A Review of the 2013 Diavik Diamond Mine Wildlife Monitoring Report

Prepared for

Environmental Monitoring Advisory Board

April 2014

Figure 1: a) Grizzly bear observations related to observation year. b) Average camp population related to observation year (data from Table 7 of the WMR 2013).

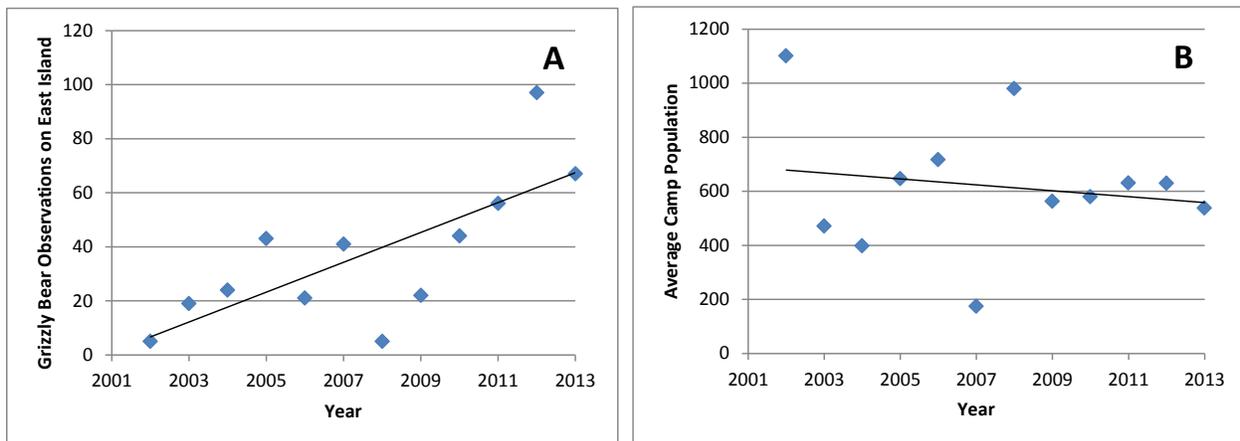
There is an increasing trend in the number of grizzly bear observations over time (Figure 1a). One reason for this could be that an increase in the number of people on site could result in more observations, yet there does not appear to be a trend in the number of people on site over time (Figure 1b).

DDMI suspects that a sow and two cubs wintered on East Island during the winter of 2011/2012. This may account for the higher number of observations in 2011 and 2012 and we do not see a decrease in grizzly bear observation in 2013. However, grizzly bear relocations had to be implemented in both 2012 and 2013. The increase in bear sightings in more recent years may also be a function of DDMI's change in management approach to not deter grizzly bears "if they mind their own business" (Annual Board Meeting, May 30, 2012). Bear deterrent activities appear to have resumed in 2013 and there were 19 occasions when a helicopter was used as a deterrent. **Given the increase in grizzly bear observations near the mine, DDMI should increase vigilance and future years of data collection should be used to evaluate whether the re-instated deterrent system is effective at reducing grizzly bear presence near the mine.**
